SERVICE BULLETIN

REFERENCE BODY
NUMBER 020
DATE 06-09-89
MODEL MR2 (AW)

ADDITIONAL ENGINE UNDER-COVER

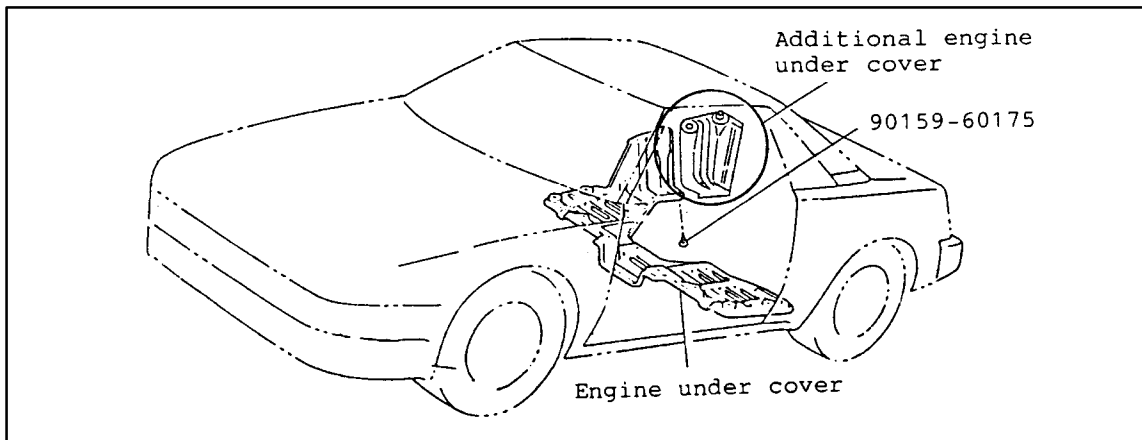
To prevent road debris and water from splashing on the alternator, an engine under-cover has been installed (see illustration).

PART NAME	PREV P/N	NEW P/N
Cover, Engine under	N/A	51443-17010
Screw*	same	90159-60175

*Additional screw needed for attachment of cover
